## Detailed Site Plan The Standard at College Park

**DSP-19068**

STAFF REPORT

SUBJECT: Detailed Site Plan DSP-19068  
The Standard at College Park

*Figure 1: South and North Elevations*

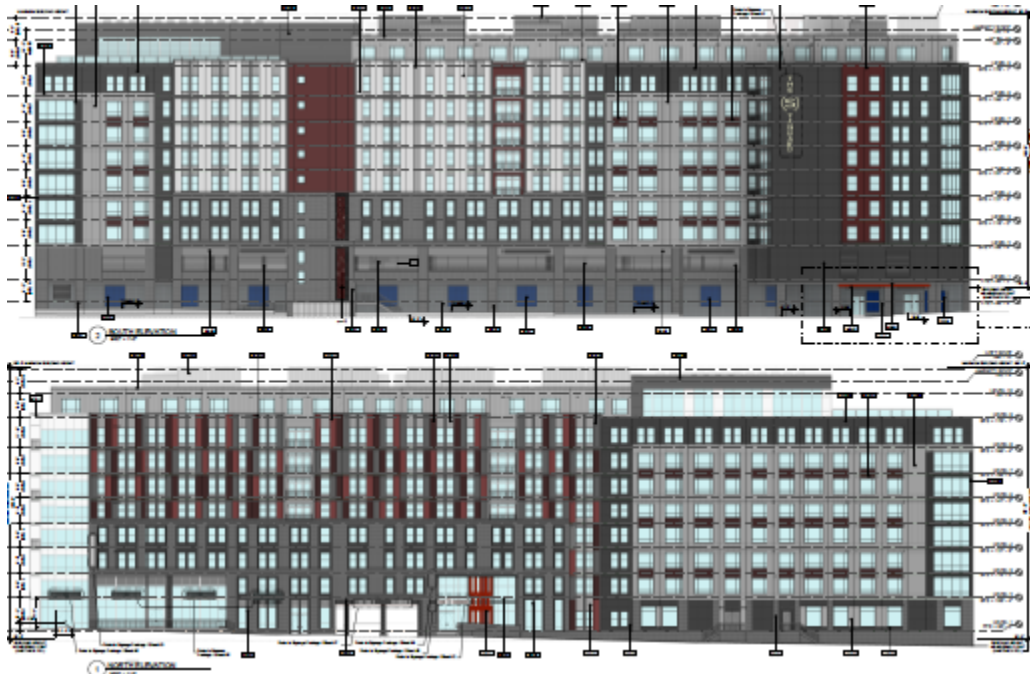
A continuous expression line is shown along the Hartwick Road elevation from the west side of the elevation through the lobby and leasing area only. The applicant’s justification is that the long façade needs to be broken up to allow variation. Staff supports the proposed design, as it will benefit the development, and recommends **approval** of this amendment.

- m. Provide at least one car sharing parking space.
    - n. Provide a continuous expression line above the second floor along the Hartwick Road façade and extend the balconies on this façade to meet the expression line.

Figure 3: Signage

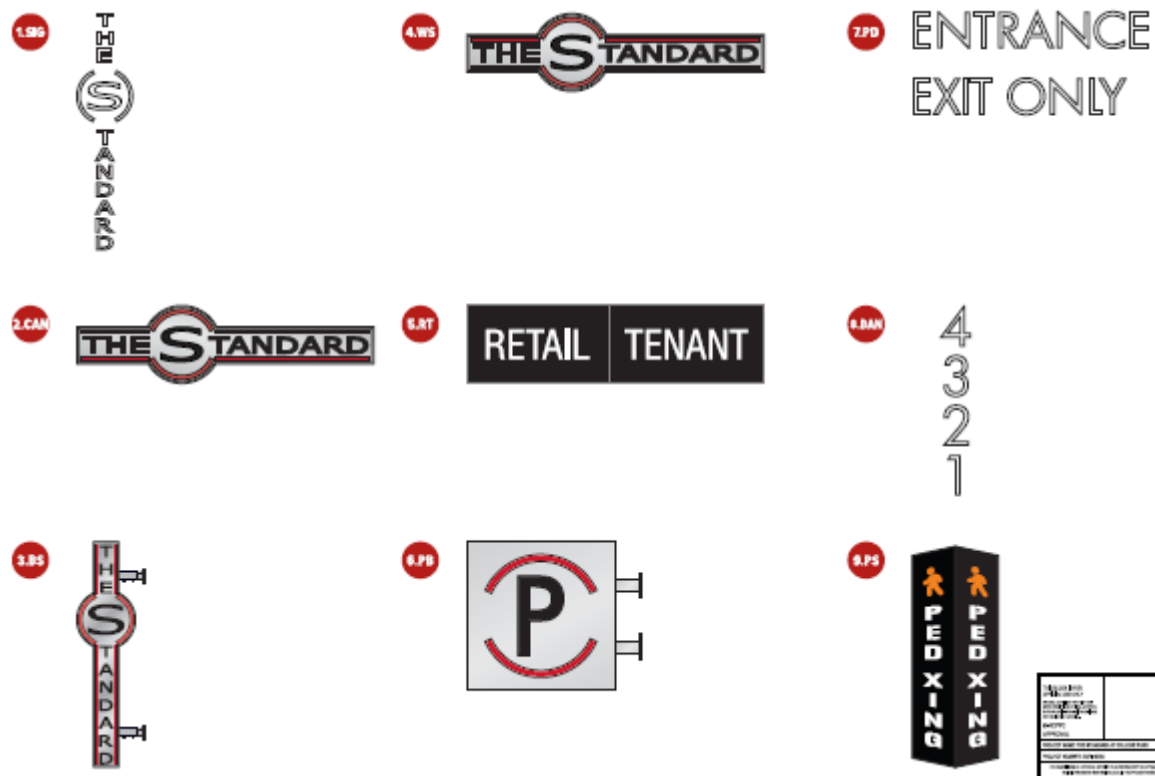
The development includes a blade sign that is 34.61 square feet. The blade sign is designed to be affixed to the north façade of the building (primary frontage), between the third and fourth levels. This sign identifies the building and is of an appropriate scale and location for adequate visibility to vehicular traffic. Staff supports the proposed sign and recommends **approval** of this amendment.

- (3) Where feasible, show trees planted along the sidewalk edge on applicant's property to align with street trees for more effect.
  - s. Revise the sign plan to clarify sign construction details to ensure that panelized back lighting and box lighting fixtures are not provided.
